# AMPEX

SERVICE BULLETIN

DATE: 20 March 1953  
MODEL: 300  
BULLETIN NO: 2  
PAGE NO: 1

## ADJUSTMENT OF AC SOLENOIDS ON RECORDERS BELOW SER. NO. 500

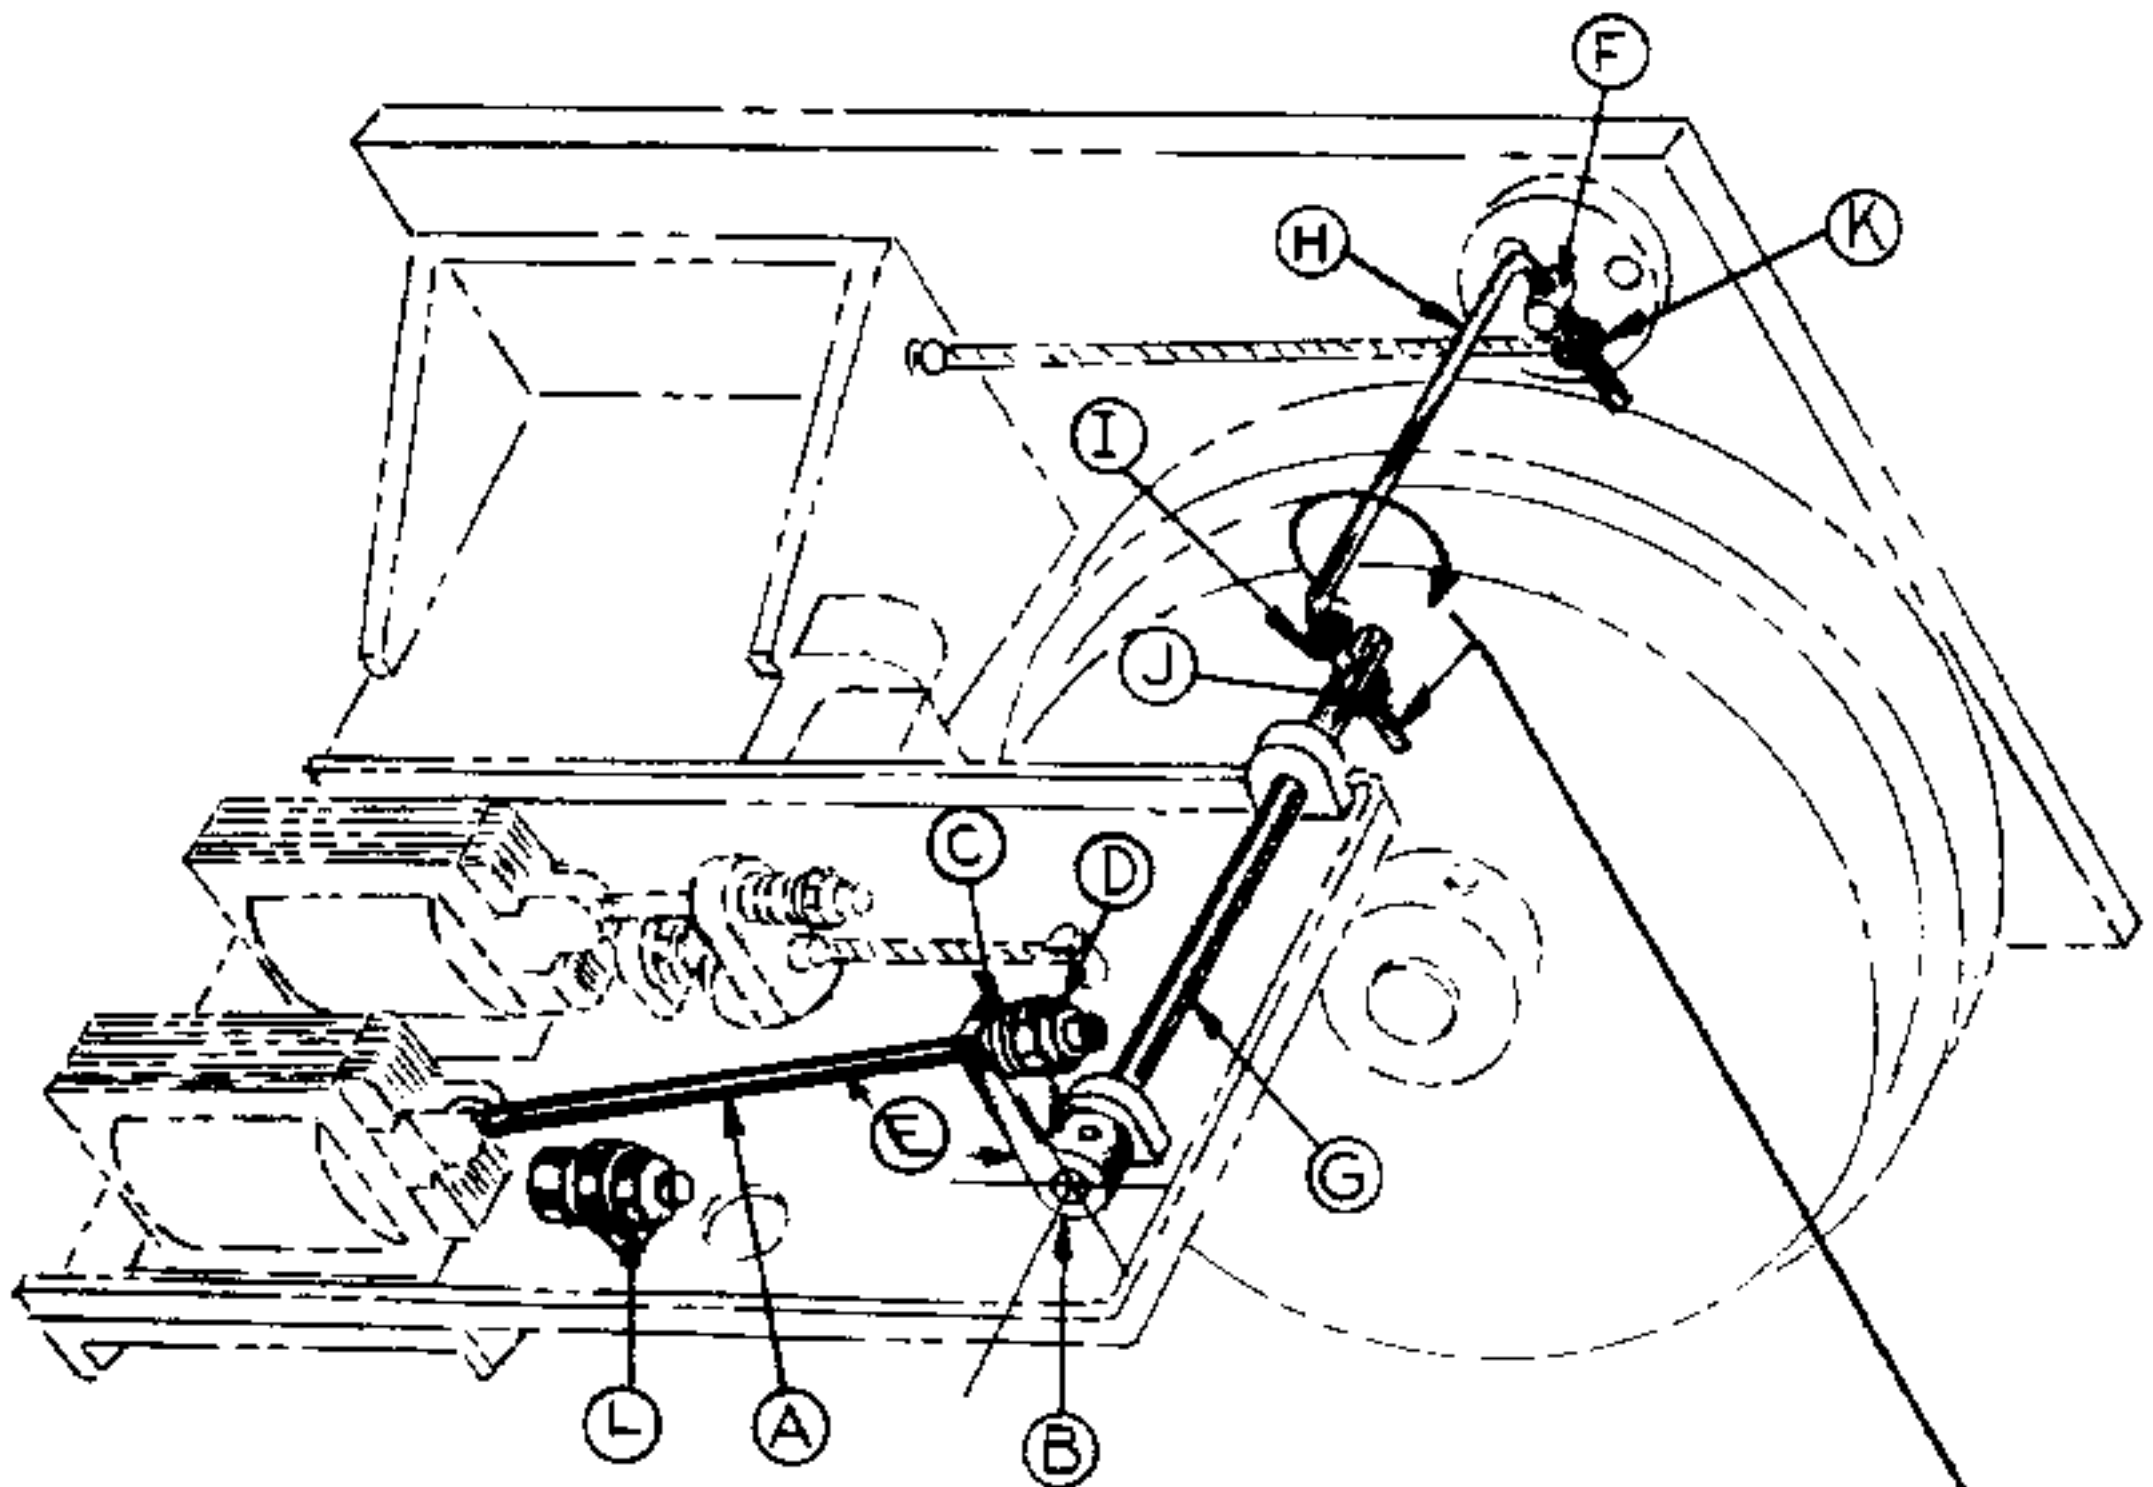
The importance of maintaining the above angle E below  $90^{\circ}$  was only recently discovered, and it is possible that some machines have been shipped in which this angle might be too great. While no machines have been shipped with noisy solenoids, it is possible that if the above adjustment is not proper the solenoids may become noisy in use. Should this be the case, the adjustment can be corrected as follows:

It will be noted that the capstan idler arm shaft F is connected to the operating shaft G below through a U-shaped torque link H. If the bottom (or shorter) arm of this link H is bent in a clockwise direction (when looking at the link from the bottom or short arm end), this will effectively reduce the angle E. In order to bend this arm, it is necessary to remove link H and hold it in a vice. The link can be removed by forcing off the spring-lock washers which position the lower arm (I and J) and which attach the return spring at the top (K). The proper value for the angle E is approximately  $85^{\circ}$ , or when the arm H is perpendicular to the plane of the solenoid base plate.

TO REDUCE ANGLE E, BEND THIS ARM CLOCKWISE WITH RESPECT TO UPPER ARM. RESET ADJUSTING NUT D & L.

ANGLE E MUST BE LESS THAN 90° WHEN CAPSTAN SOLENOID IS SEATED.

If the angle E is changed, it will be necessary to re-set the capstan idler adjustment D. This adjustment is set so that when the capstan idler just touches the capstan, the solenoid is  $1/8$  inch shy of seating. A simple way of making this setting is to place a piece of material  $1/8$  inch thick between the solenoid armature and body and clamp the armature down on it. Then tighten the nut D until the capstan idler just touches the capstan.

It may also be necessary to reset the capstan idler solenoid Stop L. This stop should be set so that at no time during fast winding does the tape touch the capstan idler.

PLUGGING OF CAPSTAN OIL  
HOLE ON RACK MOUNTED  
UNITS

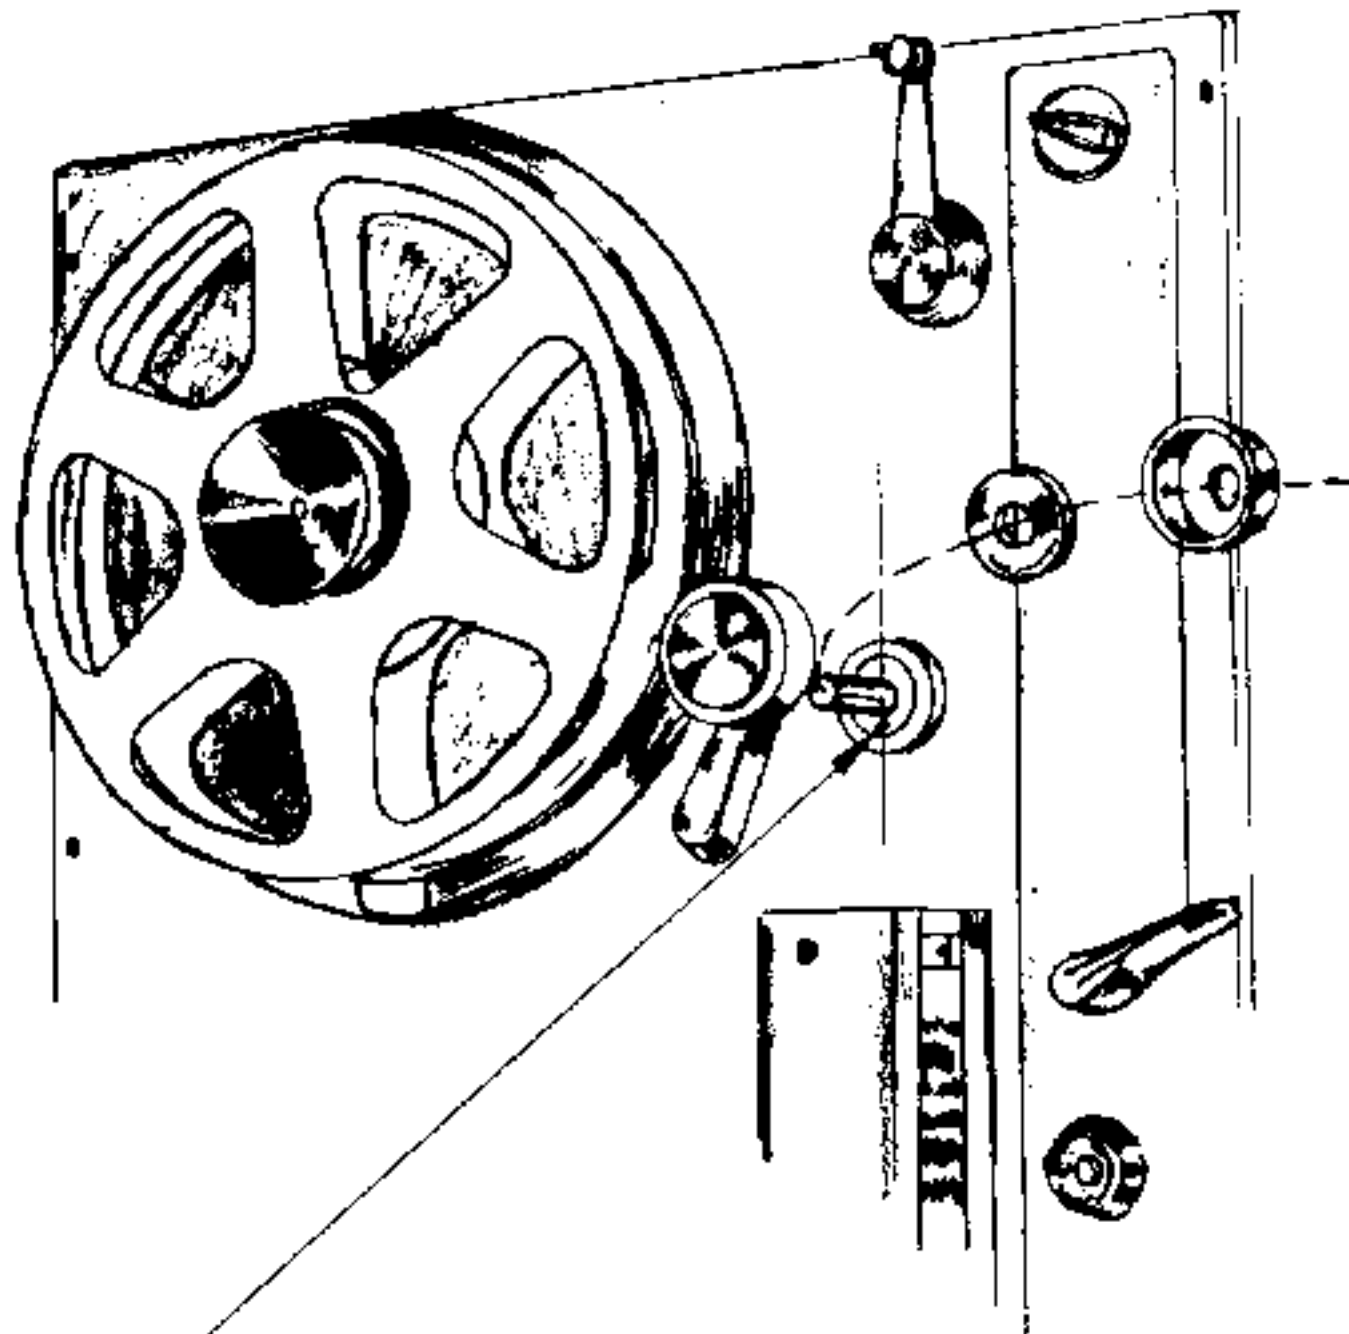
1. Capstan Oil Leakage. There is a tendency for oil to climb out of the capstan bearing housing during the first few weeks of operation. The capstan bearing has been thoroughly impregnated with oil so as to drive out any air inclusions, as the presence of air would tend to force oil out of the bearing housing when it becomes warm. The excess oil present climbs up the capstan when the machine is operated. Ordinarily, this oil is caught by the felt washer on top of the bearing housing. (The neoprene washer shown in fig. 2 of the instruction book was eliminated in production because it produced flutter.) If this washer becomes saturated with oil, which usually happens, then it will no longer behave as an effective seal. Therefore after the first week or so of operation, when most of the excess oil has had a chance to work out, the felt washer should be removed and washed out in carbon tetrachloride. Simply remove the capstan dust cap (see fig. 2, instruction book) to remove the felt washer. If this washer is kept reasonably dry, then no trouble should be experienced with oil creeping up the capstan.

REMOVE CAPSTAN DUST COVER  
& FELT WASHER AS SHOWN  
POSITION CAPSTAN ASSEM.  
SO THAT CENTER LINE BETWEEN  
BOTH HOLES IS VERTICAL WITH  
LARGE C'SK HOLE ON THE  
BOTTOM AS SHOWN. IF CAPSTAN  
SHOULD NEED POSITIONING SEE  
SVC. BULL. \*14  
TAP 6-32 N.C. IN LARGE C'SK HOLE  
INSERT 6-32 X 1/4 LG. FLAT HD. MACHINE  
SCREW.

### DRIVE MOTOR REPLACEMENT

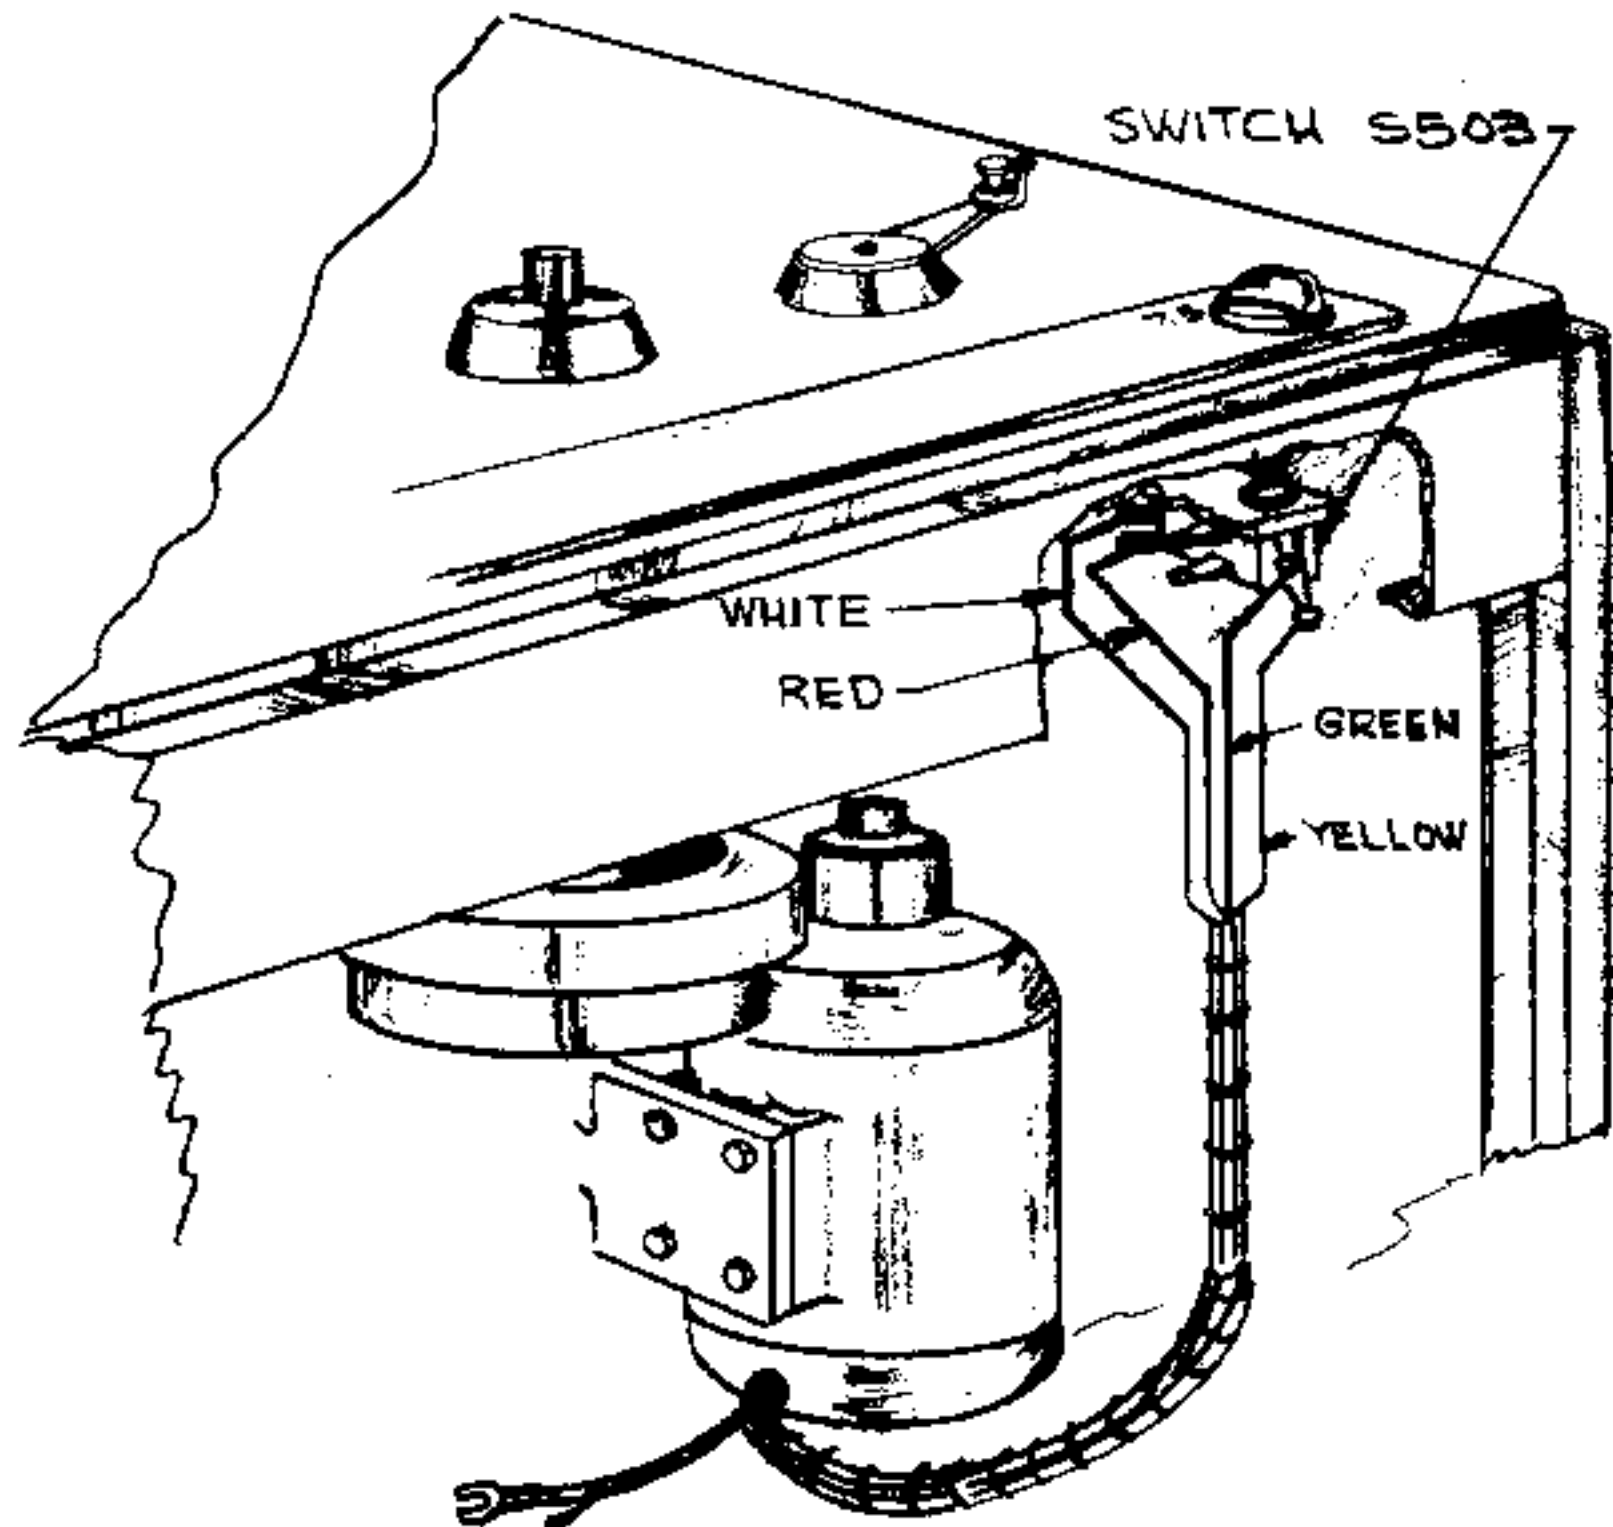
Investigation of motors which have been returned to our factory have revealed a defect in the mechanical design. These motors have therefore been returned to the manufacturer who has redesigned the units to overcome these defects in all respects. All motors which have exhibited this mechanical failure in the field are being replaced with the redesigned motor.

Install the new motor and connect as shown in the accompanying illustration, being careful to follow the color code of the leads. Before tightening the four screws in the motor base, swing the motor pulley into contact with the rubber tire and check for alignment. (Motor and Capstan shafts should be approximately parallel) A slight amount of adjustment is available due to the clearance of the holes in the hinged bracket supporting the motor.

BLACK WIRE TO NO. 1  
TERMINAL ON DRIVE  
ASSEM. TERMINAL  
STRIP TS 501
